# UNITED STATES PATENT AND TRADEMARK OFFICE

APPLICATION NO.	FILING DATE	FIRST NAMED INVENTOR	ATTORNEY DOCKET NO.	CONFIRMATION NO.
09/695,840	10/26/2000	Shinsuke Henmi	Q61431	3264

**Office Action Summary**

## **DETAILED ACTION**

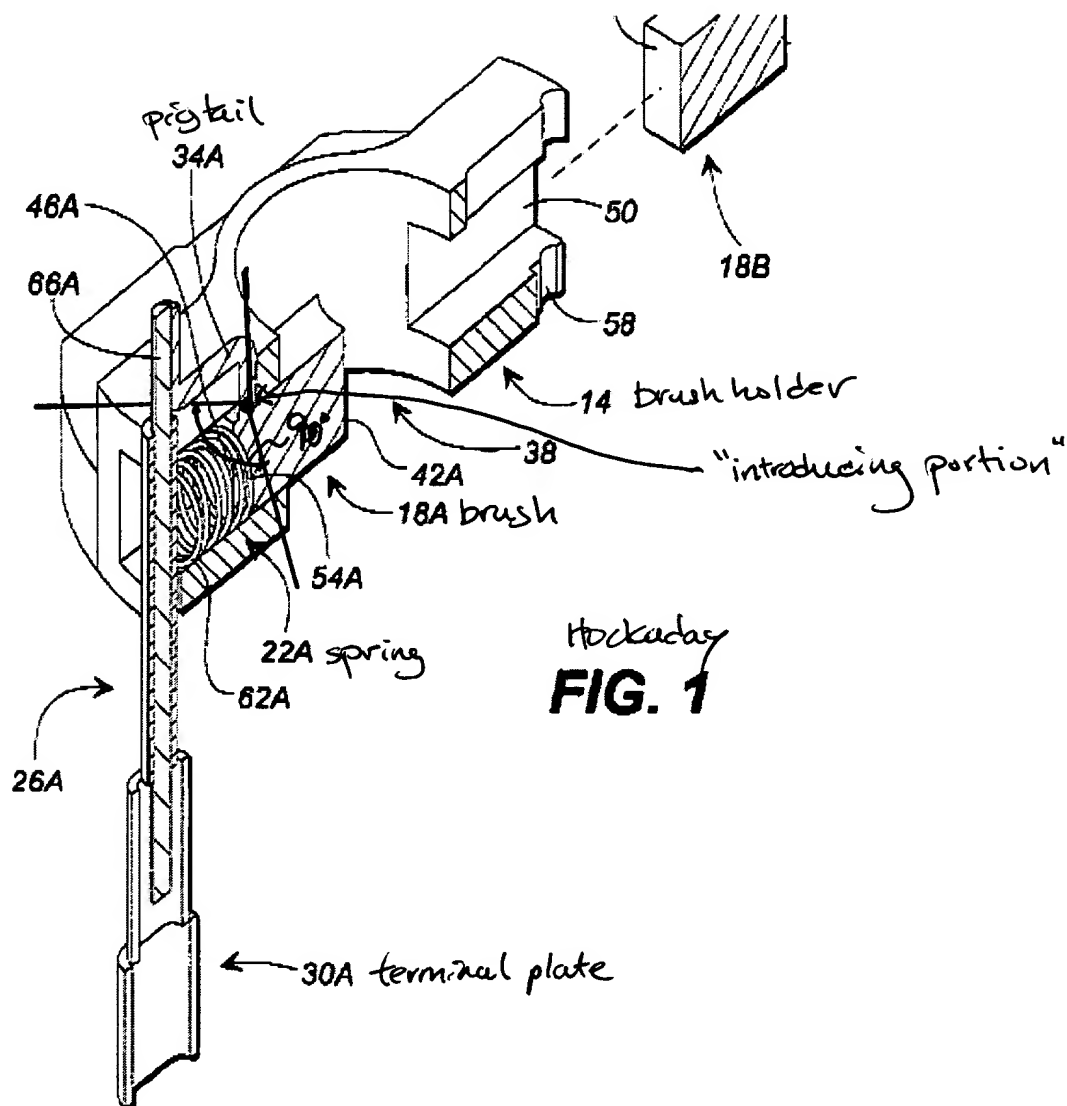
Hockaday teaches a brush holder and lead arrangement for a dynamo-electric machine comprising a brush holder (holder/card) 14 including a spring 22A and a brush 18A set in a brush holder base (slot) 50 (Fig.1). A pigtail 34A extends from an introducing portion in the brush 18A (i.e., pigtail 34A connects with brush 18A at a connection point, not numbered; Fig.1) in a radial direction of the brush holder (i.e., the pigtail 34A extends radially relative to the machine axis, as does the brush holder 14; Fig.1), and a terminal plate 30A and the pigtail 34A are connected in an area within 90 degrees from an introducing portion toward the radial direction of the brush holder (at portion 66A; see marked Fig.1 below).

Regarding claim 2, in Hockaday the terminal 30A and the pigtail 34A are connected in an area around a sliding axis of the brush “within the width of the brush” [sic] since the terminal/pigtail connection at portion 66A lies more or less radially of the brush 18A (Fig.1).

Regarding claims 3-4, in Hockaday, the pigtail is “introduced from the brush” [sic] in a direction toward a motor shaft (not shown, inherent) since the pigtail 34A is routed to the brush 18A along a generally radial path (Fig.1).

Regarding claims 5-7, in Hockaday a column comprising portion 66A extends from the terminal plate 30A to connect with the pigtail 34A (Fig.1).

Regarding claims 8-11, in Hockaday, the pigtail is “introduced from a backside of the brush” [sic] in the sense that the pigtail 34A is routed to the brush 18A along a generally radial path, from the direction of the backside of the brush, or that the pigtail connects to the brush at one end of the brush, i.e. a radial “backside” of the brush (Fig.1).
